## ATI Headquarters JSP14-40

Public hearing at the request of ATI Land Holdings LLC for approval of the Preliminary Site Plan, Wetland Permit and Stormwater Management Plan. The subject property is 12.56 acres in Section 14 of the City of Novi and located on the west side of Meadowbrook Road between Twelve Mile Road and Eleven Mile Road, in the OST, Planned Office, Service, Technology District. The applicant is proposing a 107,400 square foot research and office facility.

## PLANNING REVIEW

**SUBJECT: Accurate Technologies, Inc., JSP14-0040,  
Traffic Review of Preliminary Site Plan and Traffic Impact Study, PSP14-0158**

PRELIMINARY SITE PLAN

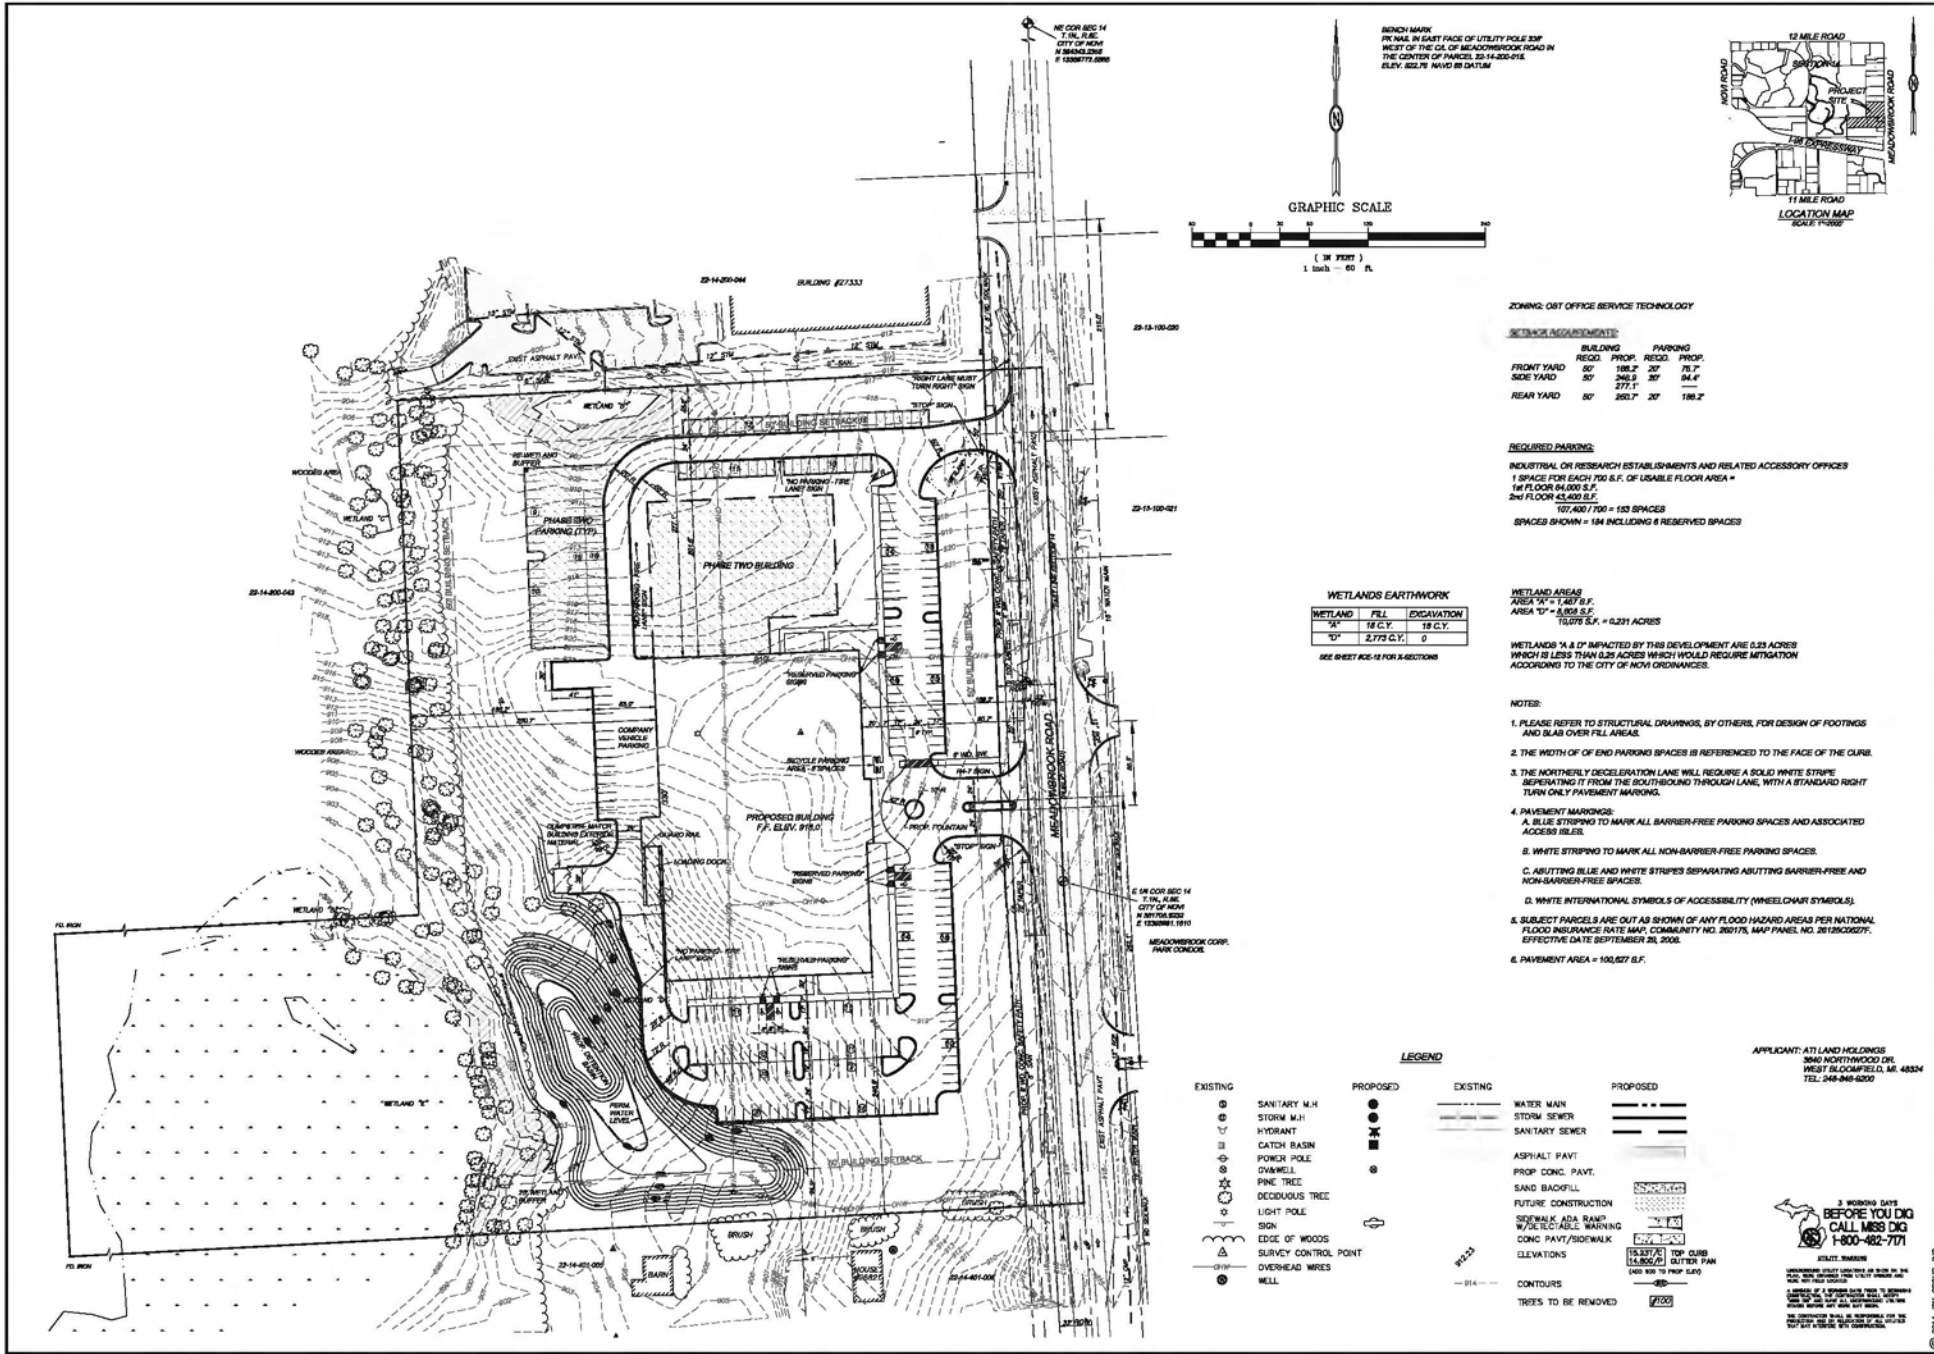
12. The proposed north drive scales 183 ft south of the existing drive to the north (near-curb to near-curb), whereas the City's Design and Construction Standards (DCS Sec 11-216(d)(1)d) requires a minimum spacing of 185 ft. **To avoid the apparent need for a same-side driveway spacing waiver, the north drive should be shifted 2 ft further south to provide a same-side, near-curb to near-curb spacing of at least 185 ft, and the plan should dimension the driveway spacing in that fashion and/or simply delete the existing center-to-center dimension.**

- a. The opposite-side driveway spacing to the north in this case is related to the potential for exiting left-turn interlock and possible cross-over movements between the ATI and MCP sites. **Since DCS Fig IX.12 requires a minimum spacing of 150 ft and the plan proposes a spacing of only 86.5 ft, a Planning Commission waiver is required.**

21. As we requested in our pre-application review comments, a 6-ft-wide sidewalk connection to the Meadowbrook safety path is proposed just north of the site's main access drive. **Per the MMUTCD, the zebra-bar crosswalk extending to the building pad should be labeled as white.**
22. The proposed ramp at the west end of the above crosswalk would be inadequate to also serve visitors being dropped off near the front doors. The grading plan now shows a continuous 0.33-ft-high sidewalk along the visitor drop-off area. **A large ADA-compatible ramp inserted directly in front of the main building entrance.**

12. To avoid the apparent need for a same-side driveway spacing waiver, the north drive should be shifted 2 ft further south to provide a same-side, near-curb to near-curb spacing of at least 185 ft, and the plan should dimension the driveway spacing in that fashion and/or simply delete the existing center-to-center dimension. *Acknowledged*
14. Since DCS Fig IX.12 requires a minimum spacing of 150 ft and the plan proposes a spacing of only 86.5 ft, a Planning Commission waiver is required. *Acknowledged*
